Olsson Associates
Consulting Engineers
1111 Lincoln Mall
Lincoln, Nebraska
January 25, 2007

ADDENDUM NO. 1

Belmont Park Grading
Lincoln Parks & Recreation No. 2007-001
City Spec. No. 07-045
OA Project No. 2006-1428

SITE PLAN OF BORE HOLE LOCATIONS

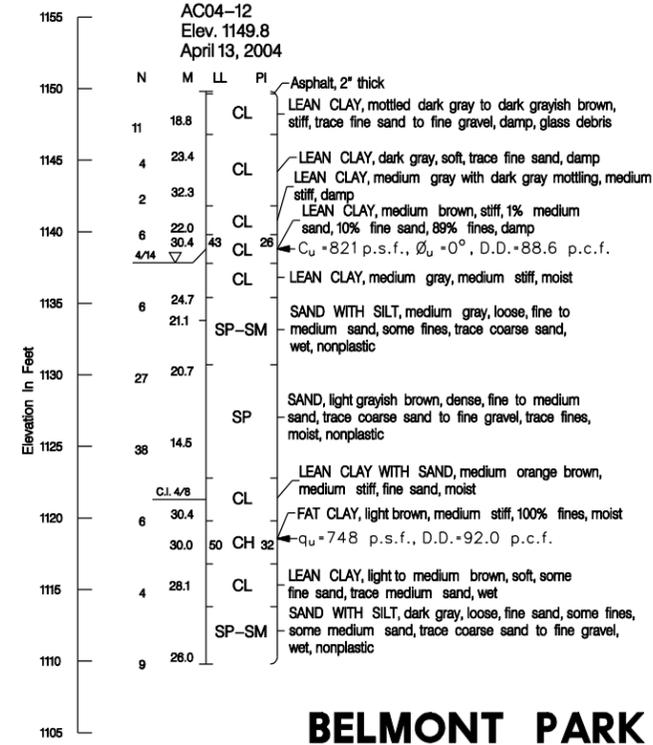
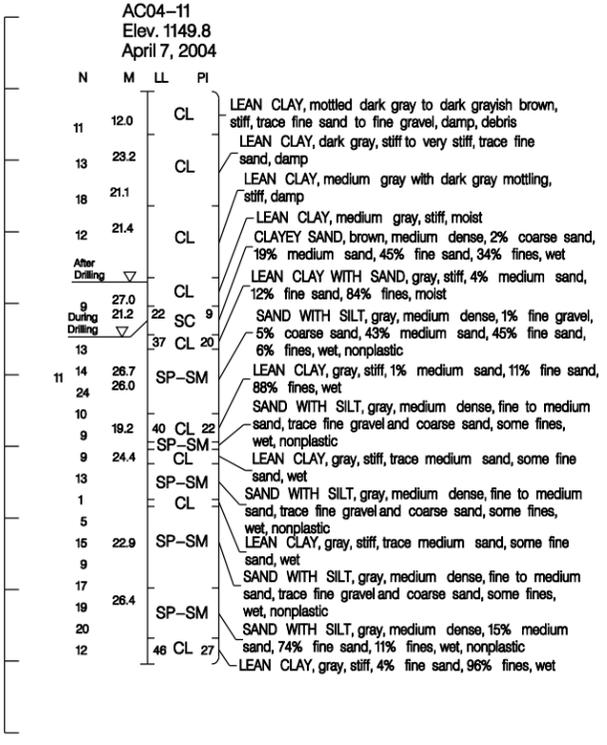
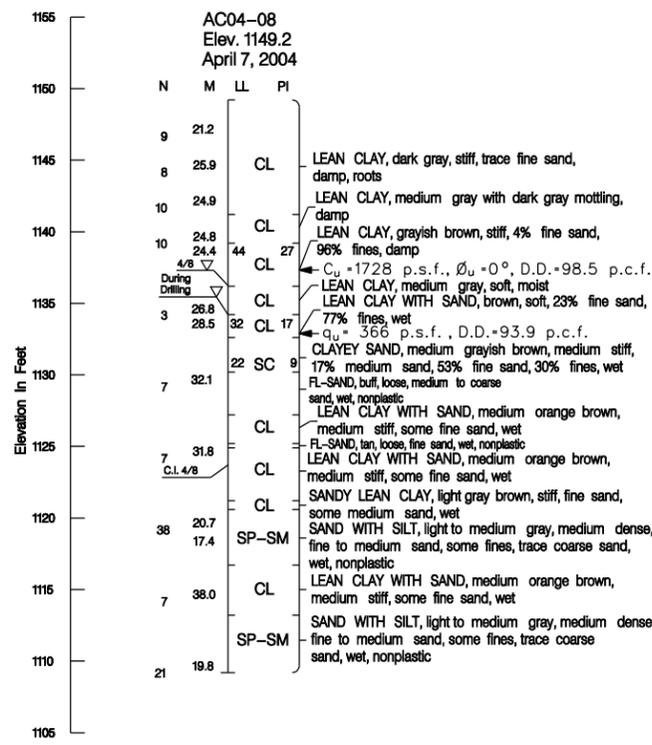
3. Soil Boring Logs – See attached drawing - Exhibit #1.
